Rattle Noise From Tail Gate When Closing

Service Category Vehicle Exterior

Section Door/Hatch

YEAR(S)	MODEL(S)	ADDITIONAL INFORMATION
2024 - 2025	Tacoma, Tacoma HV

Figure 3.

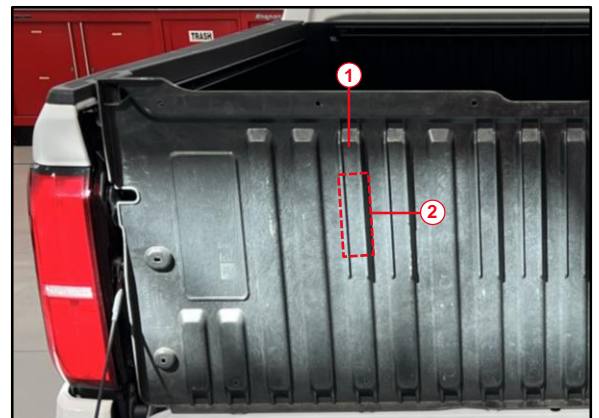
5. On the inside of the tail gate service hole cover, locate the third rib from the top left (see Figure 3).
 - A. Clean the center of the third rib with an alcohol wipe and let it dry.

Figure 4.

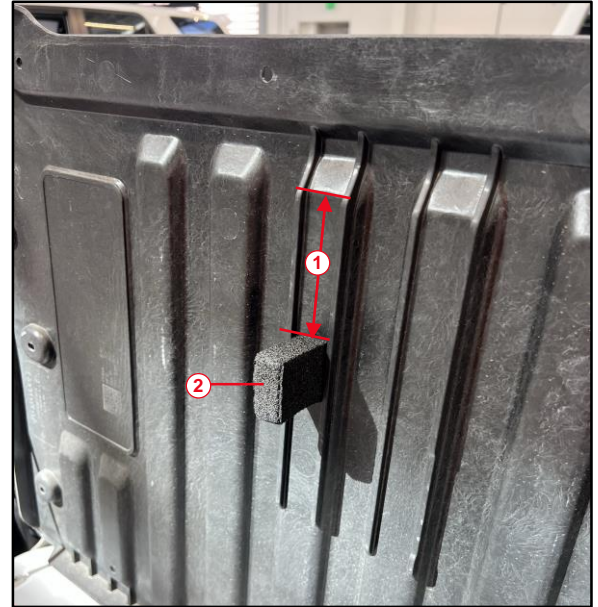
- B. Start at the end radius of the third rib and measure down 86 mm. Apply the tail gate pad (65749-AK010) in the center of the third rib, as shown in Figure 4.
